# Design changes notification for DRI0002

Involved Products	MDV 2x2A DC Motor Controller (L298N)
SKUs	DRI0002
Company	Zhiwei Robotics Corp.

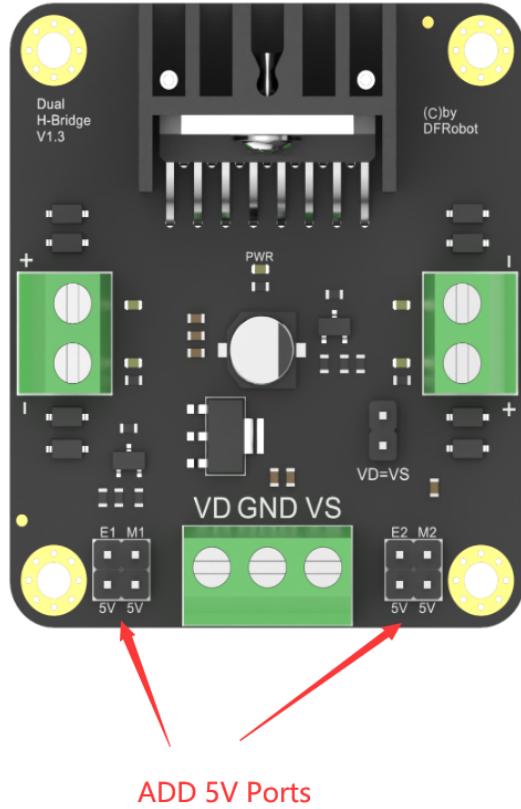
SN	Change the position of the design	Original design	New design	The impact of design changes.
1	PCBA	No 5V ports	Add 5V ports	Motor steering can be directly switched through needle arrangement

The original design did not have a 5V interface and cannot directly change the motor direction through pin arrangement.
